**RESPONSE TO UNITED STATES ENVIRONMENTAL PROTECTION AGENCY (EPA)
COMMENTS DATED MAY 16, 2007 (E-MAIL FROM PETER RAMANAUSKAS) ON THE
INTERIM MEASURES WORK PLAN (IMWP)
FOR SWMU 13 – MINE FILL B
NAVAL SURFACE WARFARE CENTER
CRANE, INDIANA**

**RESPONSE TO COMMENTS (RTCs) DATED JUNE 12, 2008
FROM UNITED STATES ENVIRONMENTAL PROTECTION AGENCY (EPA)
(E-MAIL FROM PETER RAMANAUSKAS)
ON THE INTERIM MEASURES WORK PLAN (IMWP) EPA RTCs DATED JUNE 9, 2008
FOR SWMU 13 – MINE FILL B
NAVAL SURFACE WARFARE CENTER
CRANE, INDIANA**

**RESPONSE TO COMMENTS (RTCs) DATED APRIL 10, 2008
FROM UNITED STATES ENVIRONMENTAL PROTECTION AGENCY (EPA)
(E-MAIL FROM PETER RAMANAUSKAS)
ON THE INTERIM MEASURES WORK PLAN (IMWP) RTCs DATED DECEMBER 20, 2007
FOR SWMU 13 – MINE FILL B
NAVAL SURFACE WARFARE CENTER
CRANE, INDIANA**

CONTRACT NO. 112G00352		REV 0
APPROVED BY	DATE	
APPROVED BY	DATE	
DRAWING NO. FIGURE 3 - 1		
IMWP EXCAVATION AREAS SWMU 13 - MINE FILL B INTERIM MEASURES WORK PLAN NSWC CRANE CRANE, INDIANA

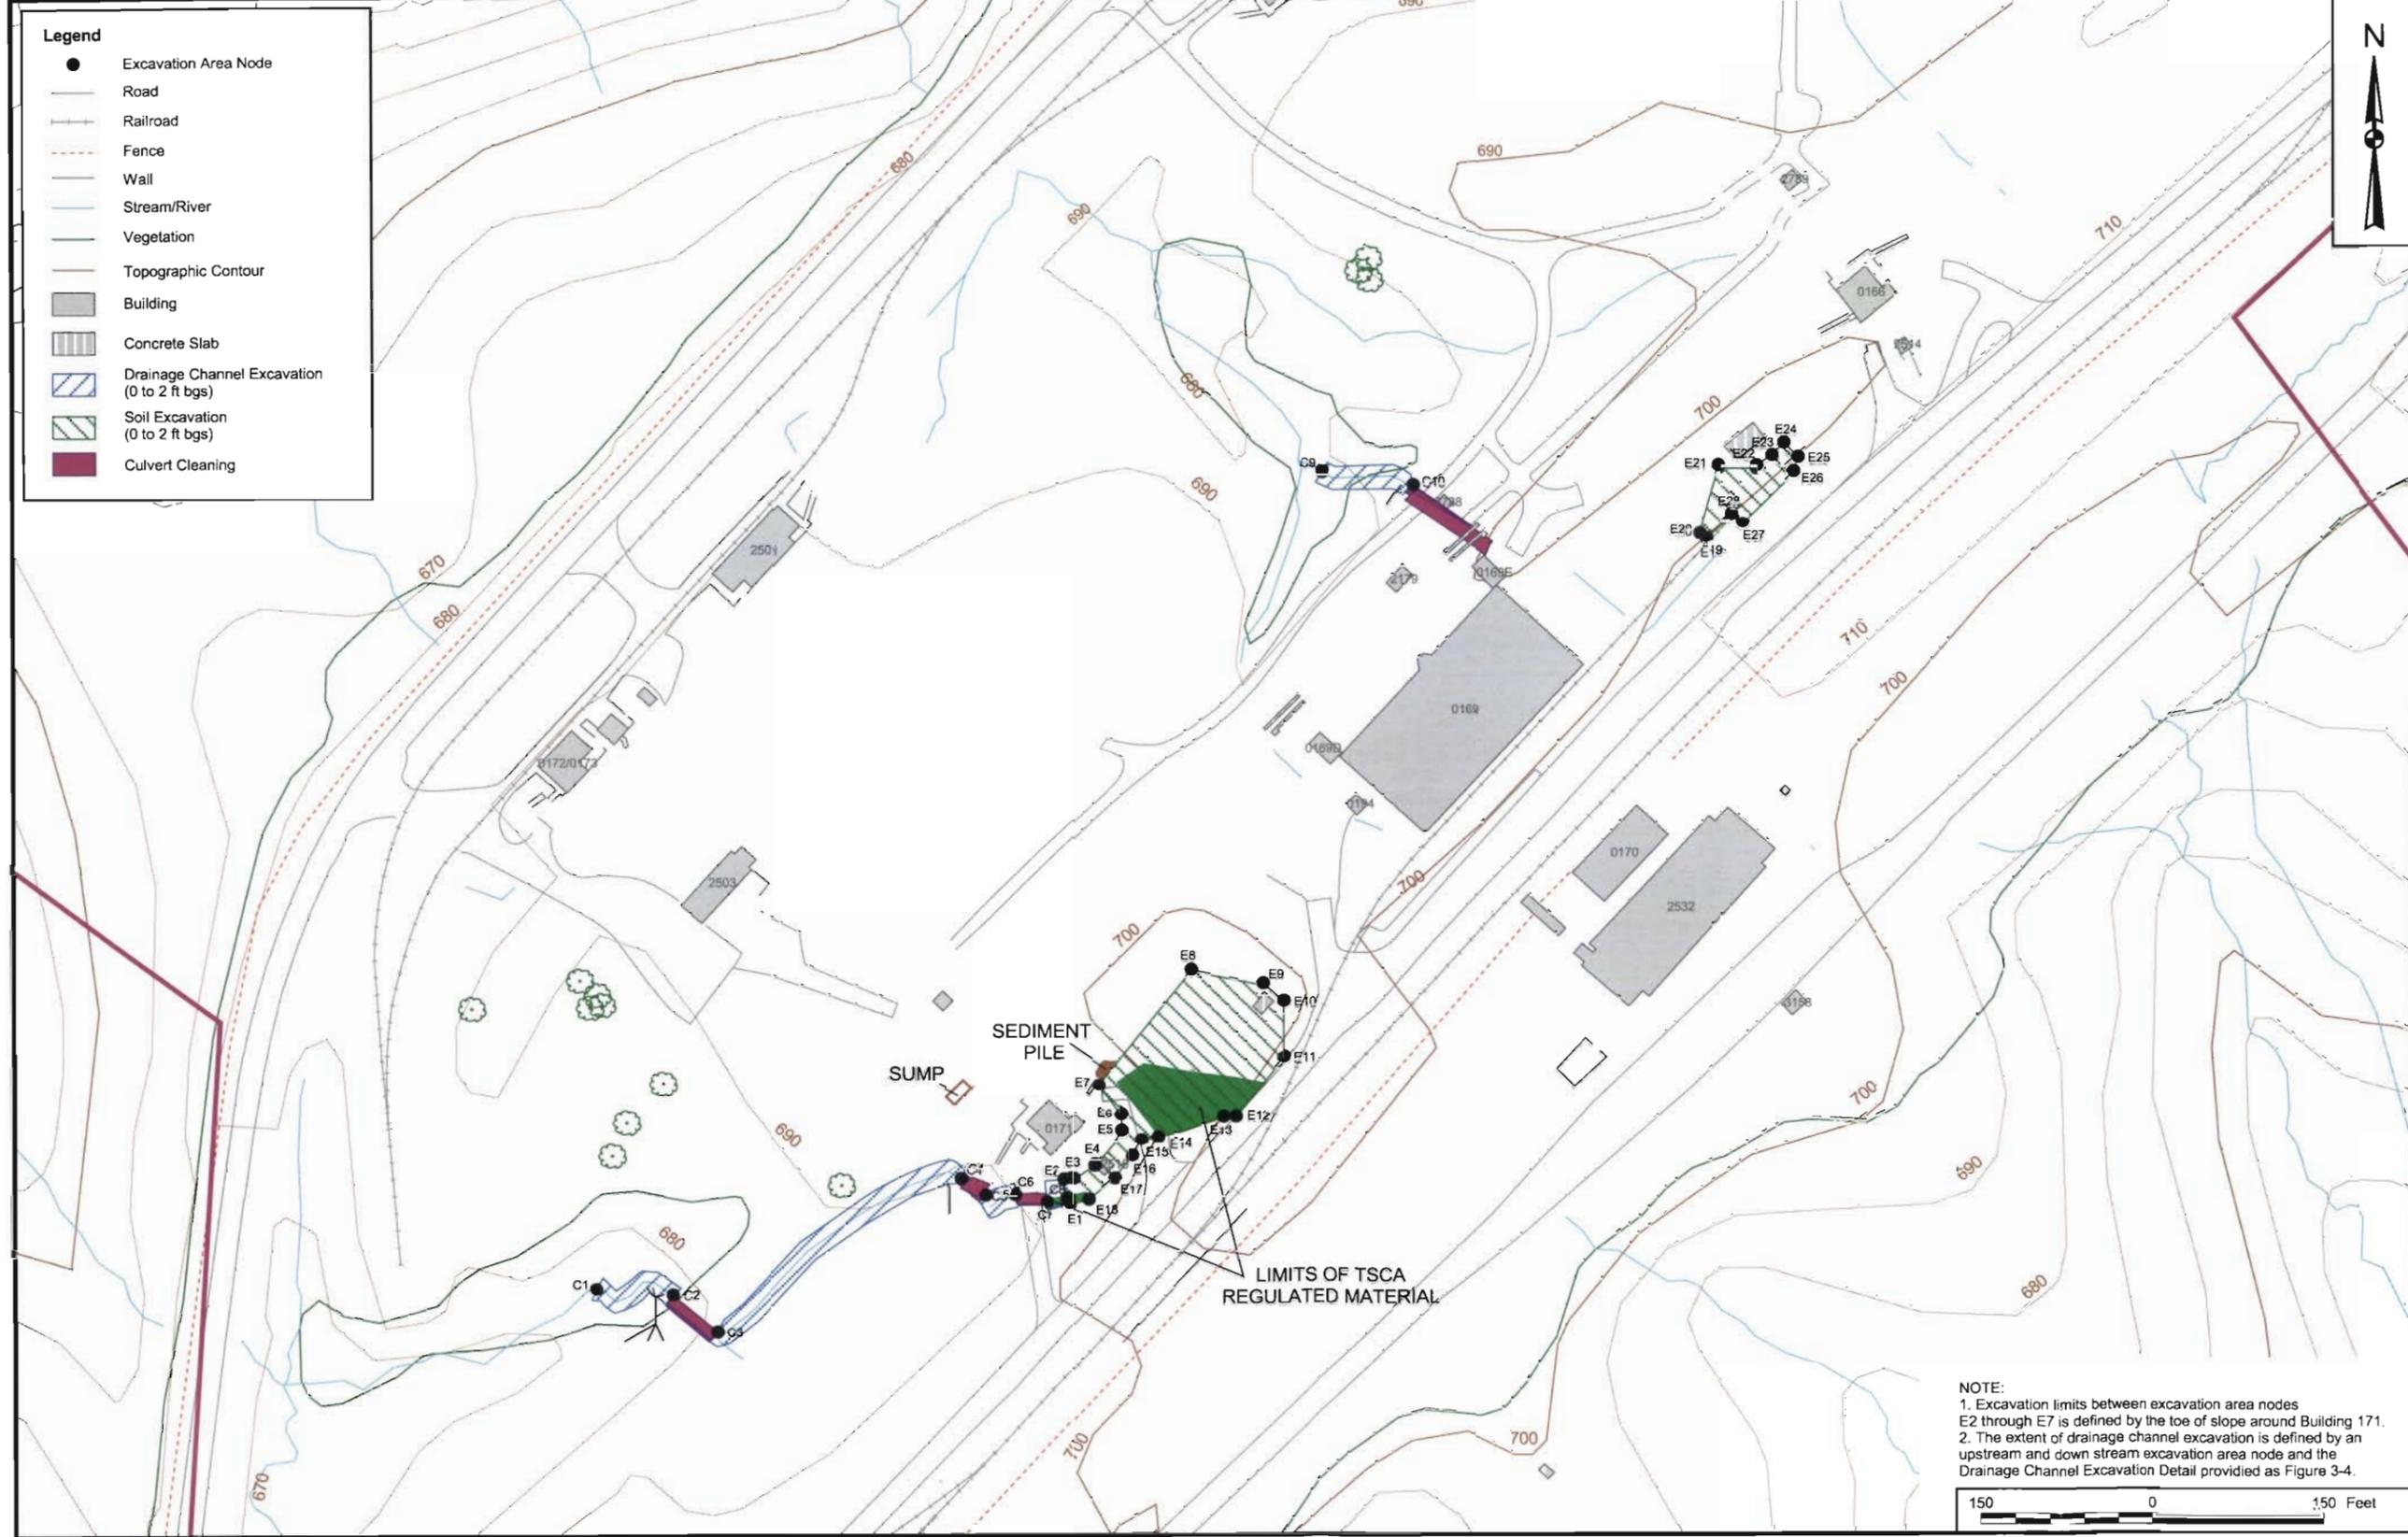
Regarding EPA-5c: At this time, under the risk-based approvals process, the TSCA program requires that > 50 ppm soils must be disposed of in a TSCA-approved landfill (not at a RCRA landfill).

Response 1c does not address the comment. Overall, the text remains confusing with respect to which buildings were known to have PCB use and which buildings are having PCB contaminated soil removed. For example, Section 3 describes work around B-169 and B-171 but does not talk about B-166 while Figure 3-1 shows work proposed around B-166. Some places in the text discuss B-166/171 and others B-169/171. Please describe work taking place at all three buildings and what the sources of PCB were at each building. If a building did not have a source of PCB, describe how PCB came to be located near the building.

“Based on the available analytical data, six sample locations contain total-PCBs at concentrations that exceed 50 mg/kg. Figures 3-1, 3-2, and 3-3 have been revised to indicate the locations of the soils that must be stockpiled separately for disposal at a TSCA regulated landfill. Additionally, the text and volume tables have been updated to indicate the inclusion of material to be disposed at a TSCA regulated landfill. Additional sampling for disposal will be performed based upon requirements of the selected landfill.

Response to EPA-1 (4-10-08): Figures 3-1, 3-2, and 3-3 indicate a fenced area northeast of Building 169 with "0166." This area is a fenced in area where the former Building 166 Therminol Boilers were located. The Therminol Boilers for Building 166 and Building 171 are believed to be the sources of polychlorinated biphenyl (PCB) contamination at SWMU 13 (Mind Fill B). PCB activities did not occur at Building 169. The purpose of referencing Building 169 is as a landmark for the remediation Environmental Multi Award Contractor (EMAC). The Navy believes that it is appropriate to use Building 169 as a landmark because of its location relative to the proposed remediation areas.

For clarification, Figures 3-1, 3-2, and 3-3 (See Attachment 1) have been modified to include a legend for the former foundation pad of the Therminol Boilers rather than fenced areas. Additionally, these figures have been modified to show Building 166.

DRAINAGE CHANNEL
VERIFICATION SAMPLING
SWMU 13 - MINE FILL B
INTERIM MEASURES WORK PLAN
NSWC CRANE
CRANE, INDIANA

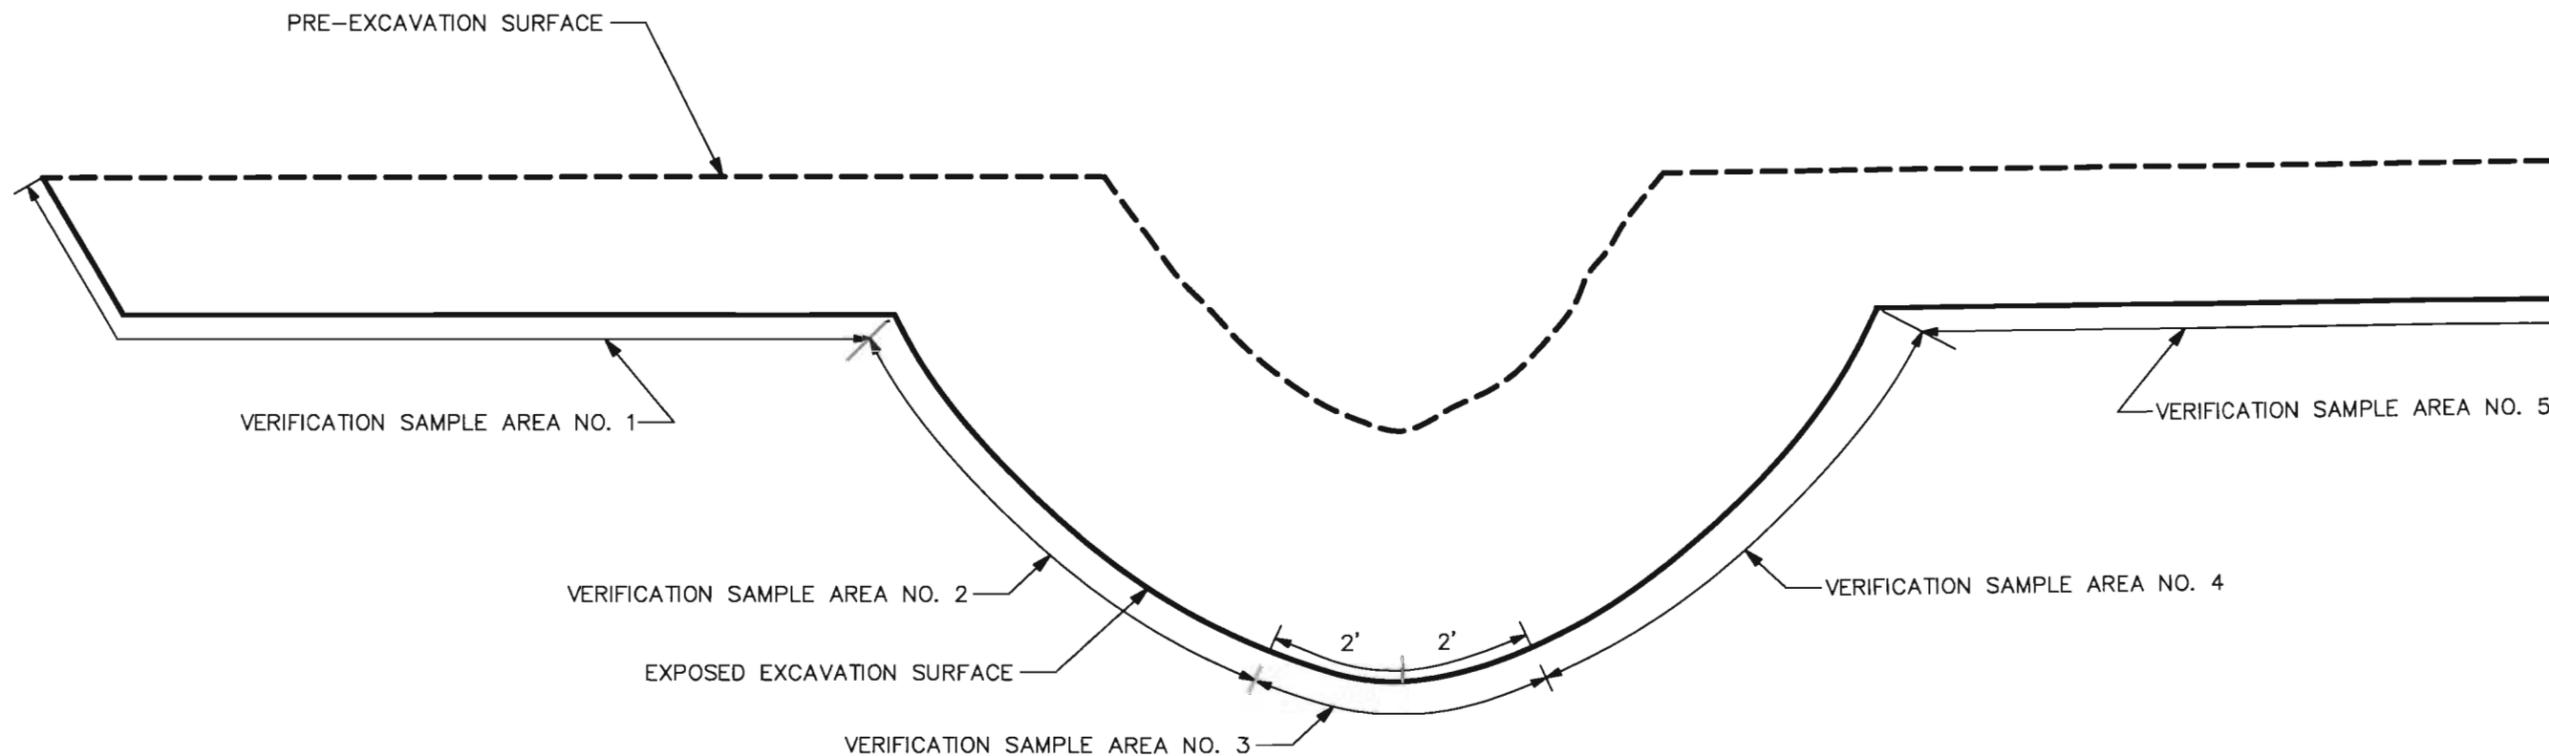
Regarding EPA-6: For the channel excavation areas, we propose you also take a composite sample every 100 ft along the low-point of the trench (i.e. along the bottom of the V/U). Since the language associated with the sampling will be incorporated in this IMWP and the approved QAPP for the project containing different sampling language will not be modified, describe how will you ensure that the contractor will be following the correct sampling scheme. Please reiterate in the IMWP how many aliquots will make up a composite sample.

Response to EPA-2(6-12-08): To accommodate the collection of an additional composite sample along the centerline of the drainage channel following excavation, the text has been revised to

include the collection of five composite samples for every 100 linear feet of drainage channel excavated. Due to the irregular shape of the excavation, the fifth composite sample will be collected from an area designated as the base of the excavation along the centerline of the channel. This area will measure approximately 4 feet wide centered on the center of the drainage channel. In addition the text has been revised to identify that 4 aliquots make up one composite sample. The text in Section 5.2, Subsection, "Drainage Channel Excavation Areas" has been revised as follows:

The revised Figure 5-1 is presented in Attachment 1.

DRAINAGE CHANNEL EXCAVATION DETAIL
SWMU 13 - MINE FILL B
INTERIM MEASURES WORK PLAN
NSWC CRANE
CRANE, INDIANA

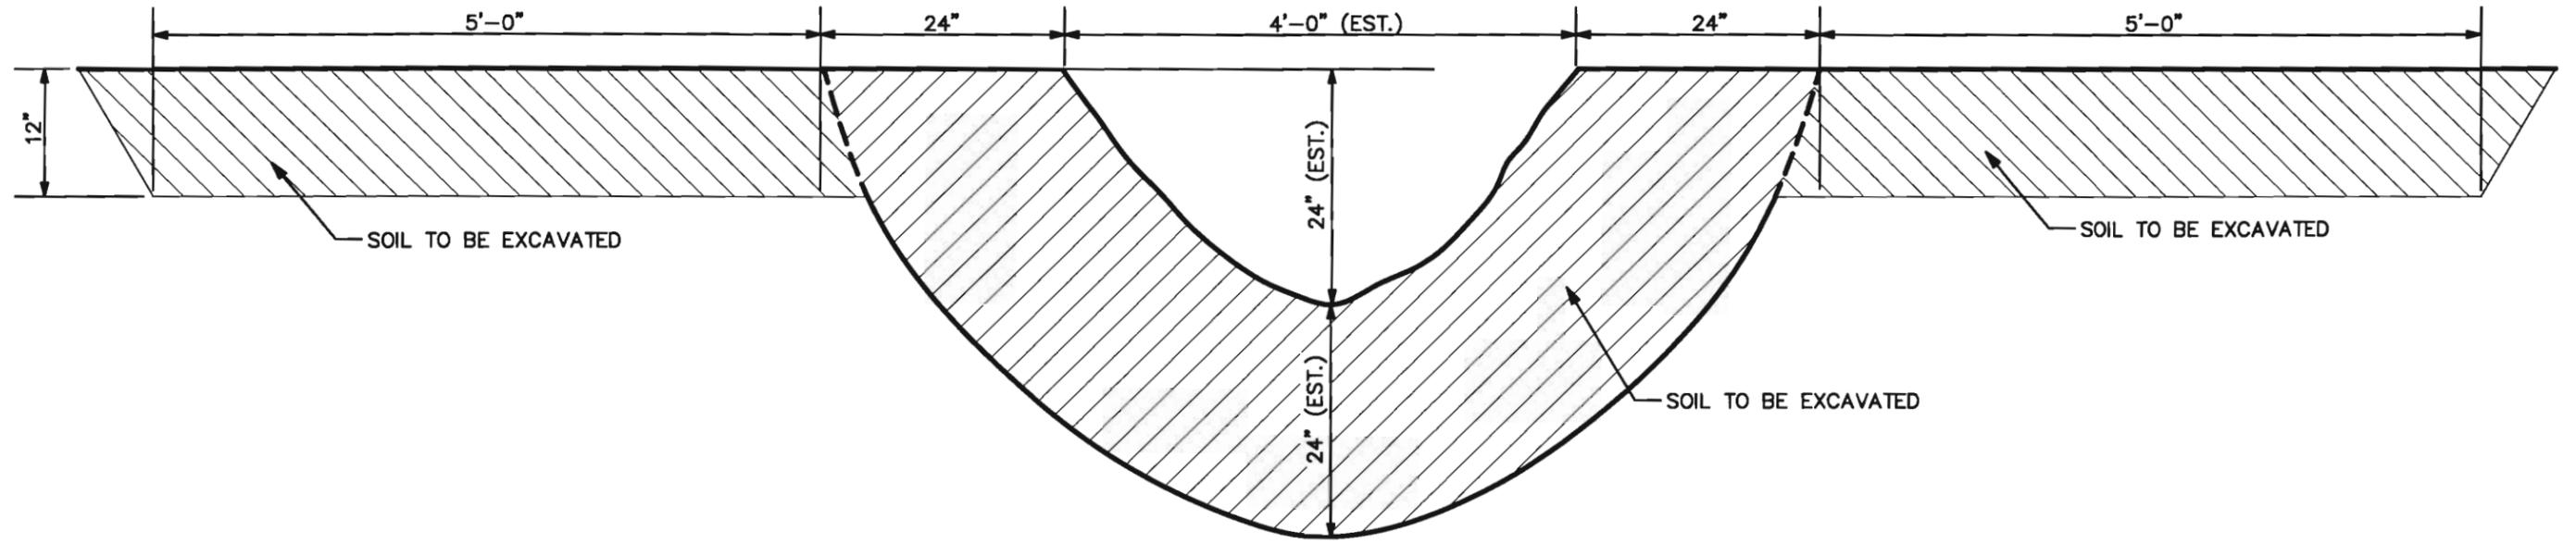
The Navy must take confirmation floor samples. The configuration of the drainage channel or excavation does not eliminate the requirement for confirmation sampling. Please propose a confirmation floor sampling plan.

Response to EPA-6(4-10-08): The excavation shape related to the drainage channel excavation is an irregular shape (see Figure 3-4 in Attachment 2). As a result of the irregular shape, verification samples will be collected from the exposed exaction floor of the channel overflow areas located on each side of the "V / U" shaped channel. Within the "V / U" shaped channel one verification sample will be collected from each of the exposed surface defining the sides of this "V / U" shaped excavation. To illustrate the locations of verification sample collection, a new figure (Figure 5-1 see Attachment 3) has been added to the text and is provide as part of this response to comment document.

- For the soil excavation areas, every 25 foot by 25 foot (e.g., 1 composite sample for every 625 square feet).
- For the channel excavation area of the drainage trenches, every 100 foot of excavation length. These excavations are approximately 6 foot by 100 foot (see Figure 3-4) (e.g., 1 composite sampler per 600 square foot).
- For the channel-overflow excavation area of the drainage trenches, every 100 foot of excavation length. These excavations are approximately 5 foot by 100 foot (see Figure 3-4) (e.g., 1 composite sampler per 500 square foot).

- *"Drainage Channel Excavation Areas - Verification samples will be collected from the excavation sidewalls and floors. Due to the irregular shape of the drainage channel excavation (see Figure 3-4), two verification samples will be collected from the exposed overflow floor areas located on each side of the channel (i.e., from the channel overflow areas) and two verification samples will be collected from the exposed surfaces of the drainage channel (Figure 5-1). Verification samples will be composite samples as described in the QAPP (TiNUS, 2006). These four composite samples make up one set of verification samples. At a minimum, one set of verification samples will be collected from each drainage channel segment and for every 100 linear feet of drainage channel excavation. In the event that a drainage pipe is encountered during the drainage channel excavation process, the frequency of verification sample collection will be increased to one set of verification samples for every 25 linear feet of drainage channel excavation. Therefore, based on the proposed length of drainage channel excavation within 100 feet downstream of the piping outlet areas, if drainage pipes are not encountered, seven sets*
